UNITED STATES PATENT AND TRADEMARK OFFICE

APPLICATION NO.	FILING DATE	FIRST NAMED INVENTOR	ATTORNEY DOCKET NO.	CONFIRMATION NO.
09/816,671	03/26/2001	Kazunori Matsumoto	43890-504	5732

Office Action Summary	Application No. 09/816,671	Applicant(s) MATSUMOTO, KAZUNORI	
	Examiner McDieunel Marc	Art Unit 3661

DETAILED ACTION

FIG. 1

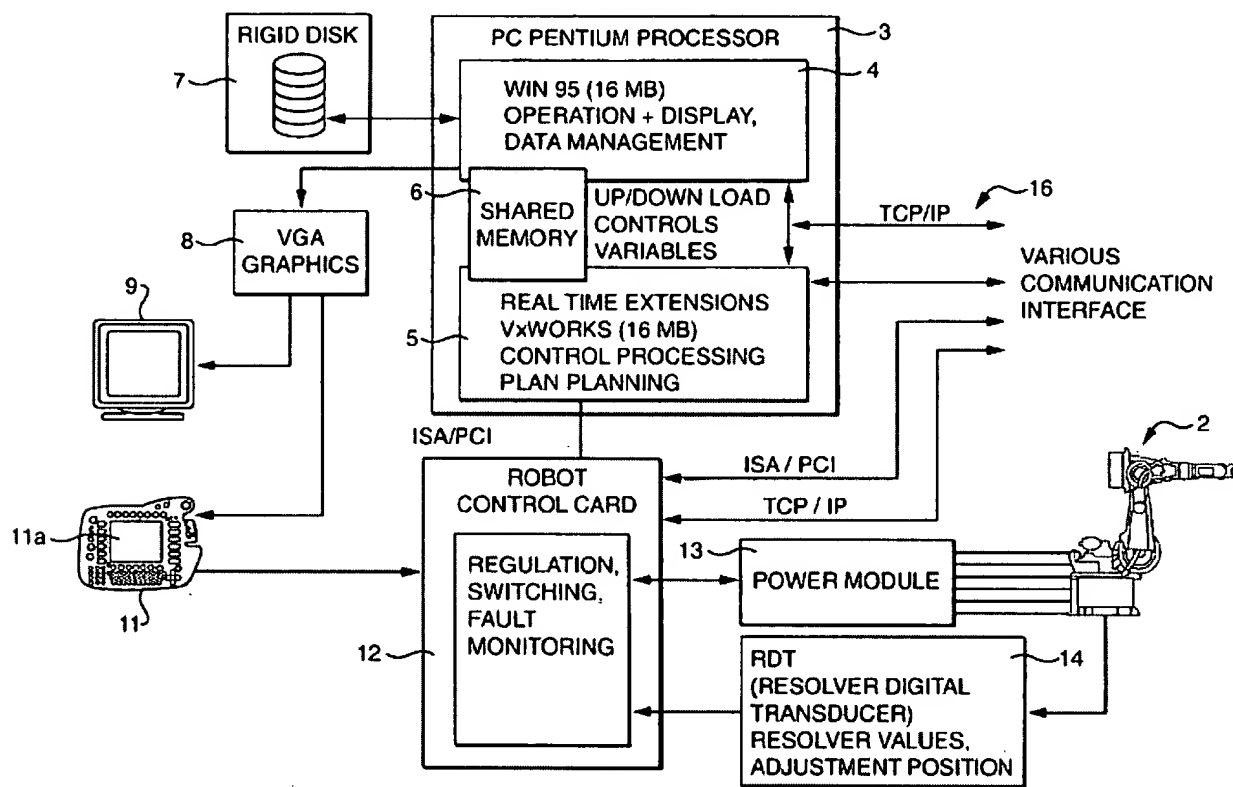
8. Claim 1 is rejected under 35 U.S.C. 102(e) as being anticipated by Grob *et al.*, (U.S. Pat. No. 6,356,806 B1).

Grob *et al.* teaches an industrial robot, comprising:

a robot (see Fig. 1, element 2), please note that element 2 being a KUKA robot body;
a manipulator to control the operation (see Fig. 1, element 12 and col. 3, line 32), please note that “the robot control card 12 controls the robot 2”, and please bear in mind that element 12 works in collaboration with a standard PC computer as taught by Grob *et al.* as to the limitation of “said robot body” (see Fig. 1, element 2);

a control device (see Fig. 1, element 11) to control said manipulator (see Fig. 1, element 11);

a first path disposed between said manipulator and said control device (see Fig. 1, elements 11, and 12), please note that the arrow being considered as the path between the manipulator and the control device; and

a second path disposed between a commercial power source (see Fig. 1, element 13) and said manipulator (see Fig. 1, elements 13 and 12), please note that the “power module” of Grob *et al.* being considered as a commercial one, since Grob *et al.* discloses a “battery” and “DC voltage using a battery/accumulator” (see col. 4, lines 14 and 67) and the arrow that connects

between elements 13 and 12 of figure 1 being taken for the second path (see Fig. 1, elements 13 and 12).
